# Access Compliance Report

## Public Rights-of-Way

### (Curb Ramps)

Intersection ID: N/A	Main Street: SHARON_RIDGE_LN	Cross Street: N/A	Location: S
ADA ID: 5B09740707FB	Ramp Type: Perp	Initial Pass/Fail: Fail	Overall Compliance: No
Severity Score: 12.5			
Codes/Mitigation Info/Possible Solution		Field Measurements/Component Compliance

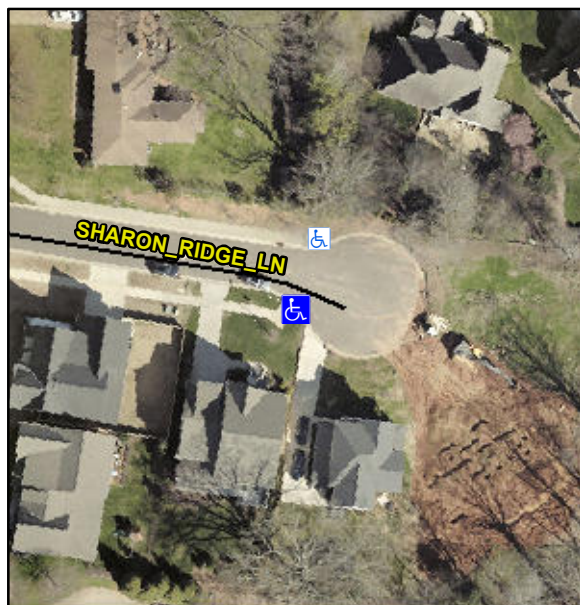
**Remove & Replace Entire Ramp.**

**Not Found, R304.5.3**
